Technical Note

CLIENT:	Extra MSA
PROJECT:	Proposed Erection of a Motorway Service Area, Land to the North of Junction 11 of the M62, Warrington
SUBJECT:	Groundwater Technical Note in response to EA letter dated 14 Feb 2020 SO/2019/119672/03-L01
JOB NO.:	SH11739
DATE:	20 March 2020
PREPARED BY:	L Ballarini: Service Area Lead – hydrogeology and hydrology

DRAWING TITLE
INDICATIVE LEVELS DESIGN

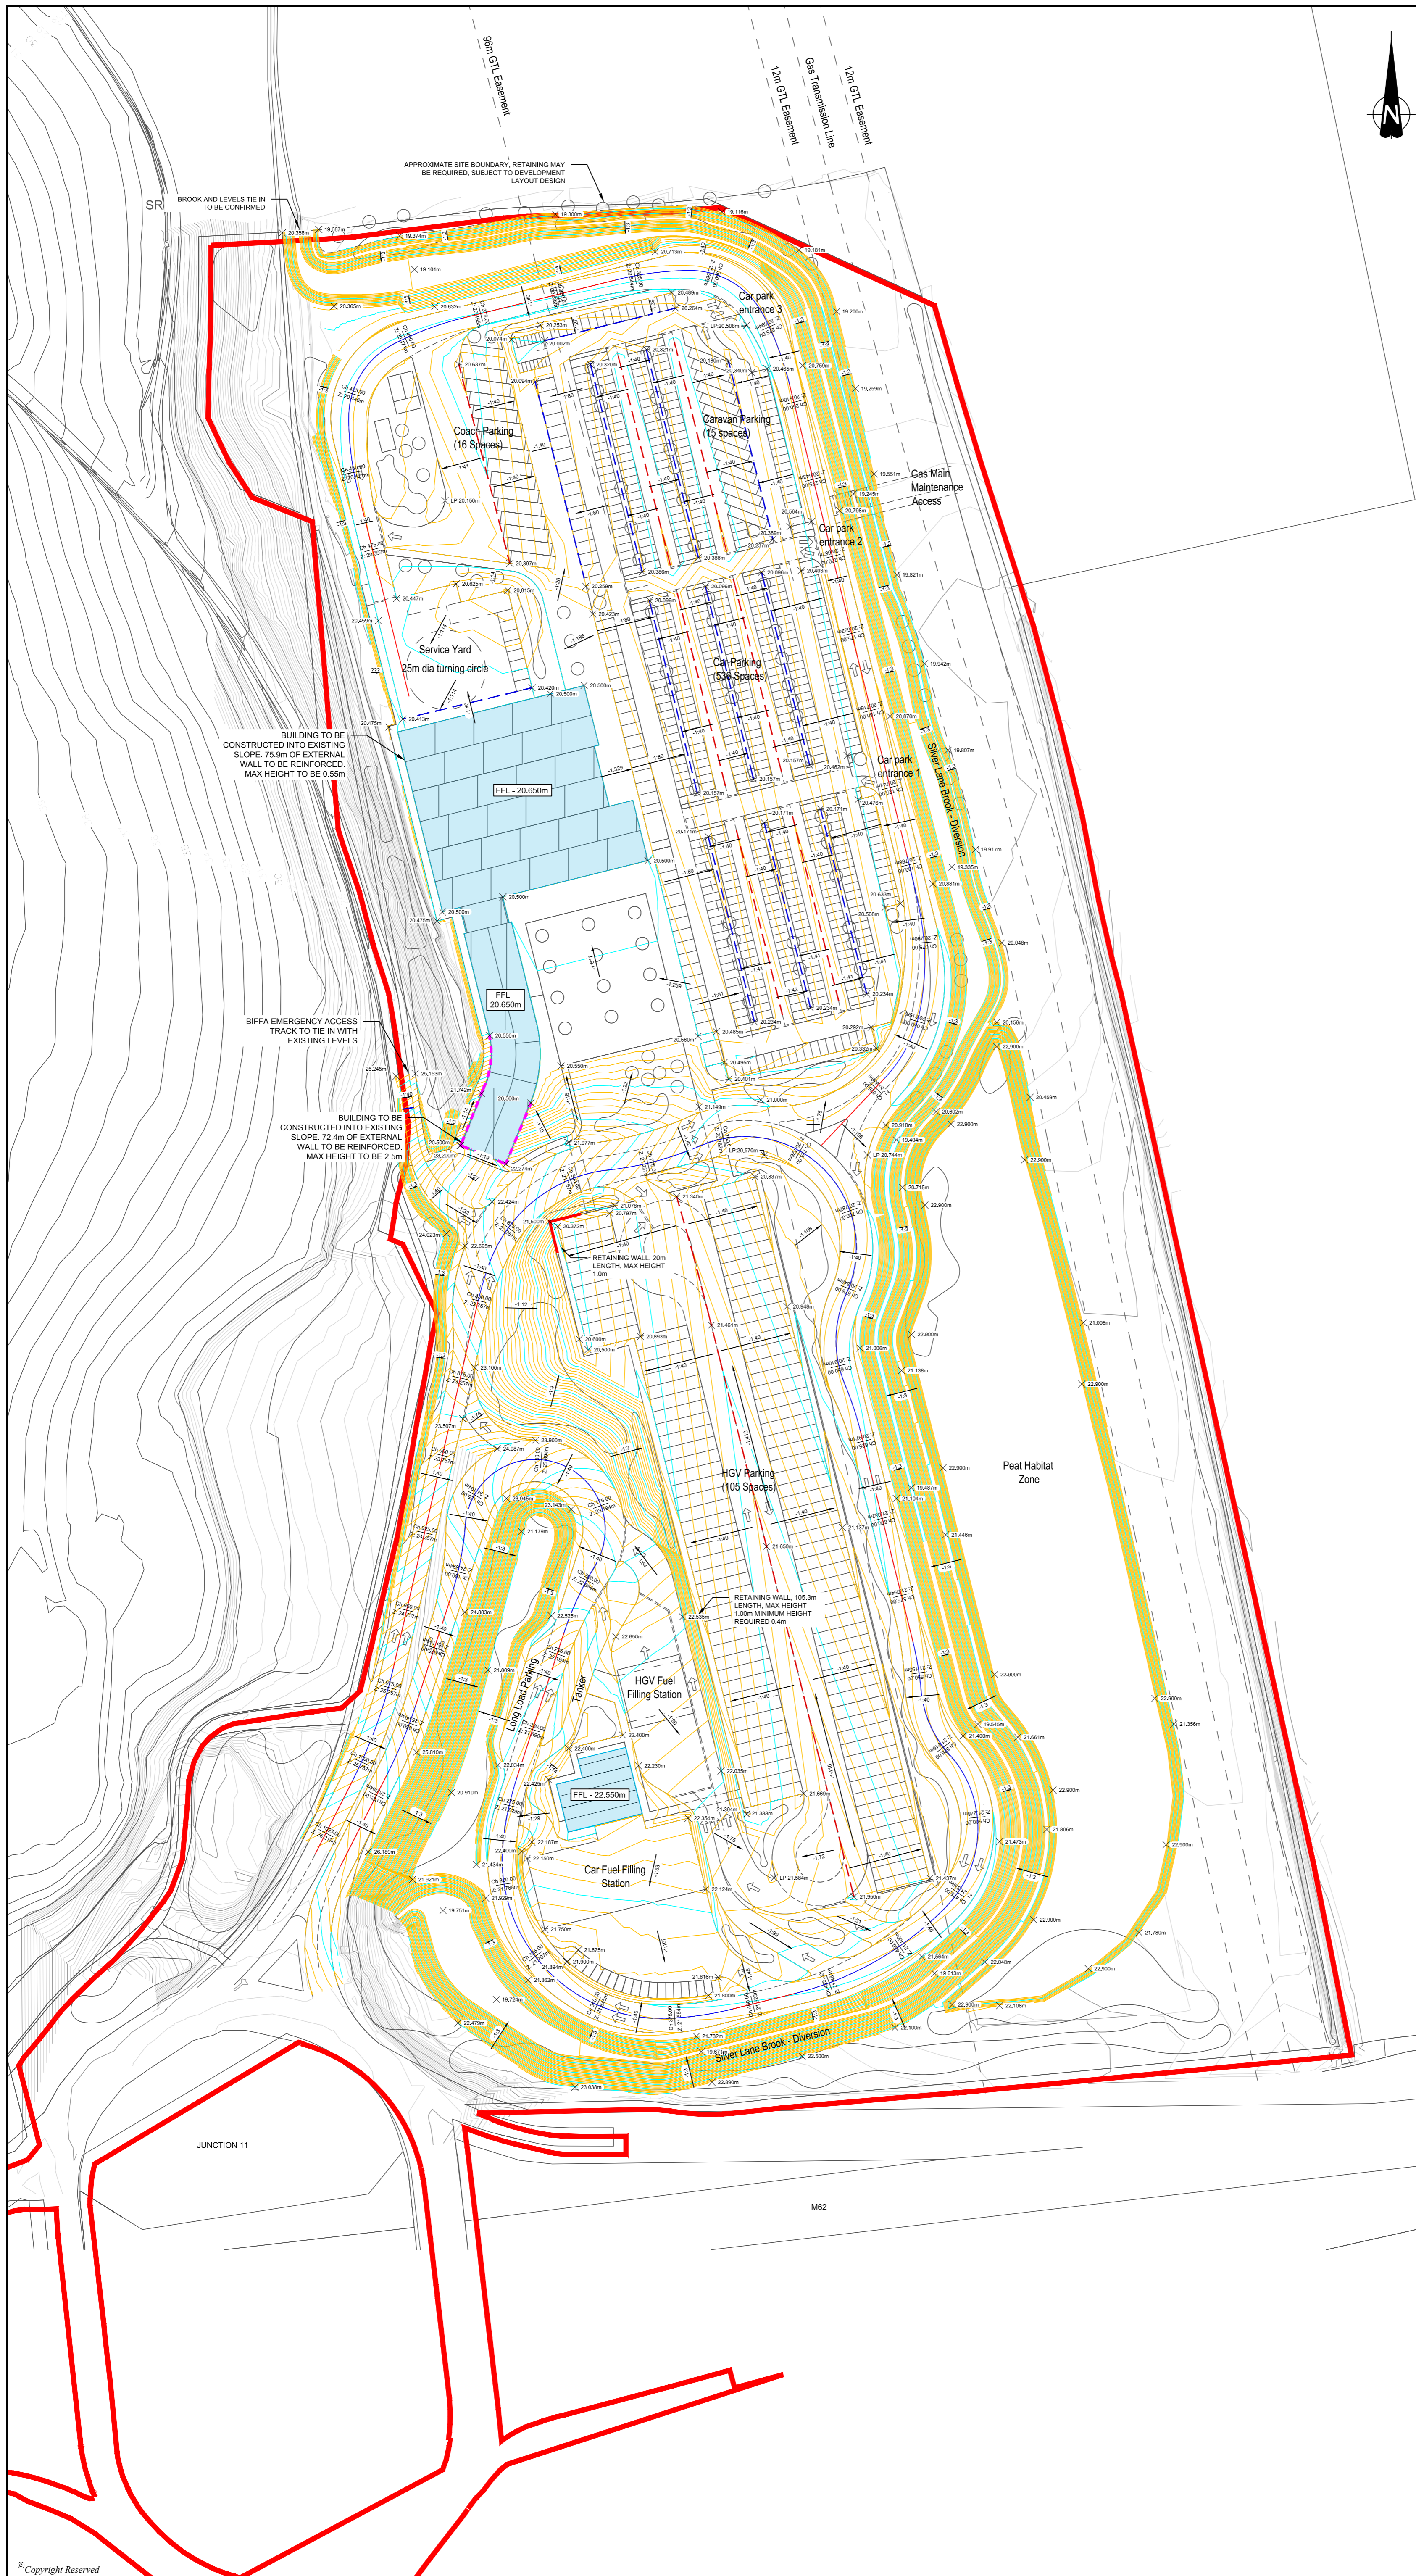
EA comment: [Provide information on] finished floor level data including expected level of brook.

In terms of finished floor levels, Architecture 519 drawing RMS-519-ZZ-XX-DR-A-0703 revision P12 titled 'Combined Parameter Plan', submitted as part of the planning application, details the general proposed site levels and finished floor levels. We also attach a new drawing, Wardell Armstrong drawing SH11739-004E titled 'Indicative Levels Design', which confirms the levels shown on the Combined Parameter Plan as well as providing additional details of the indicative levels being considered across the site and to the brook.
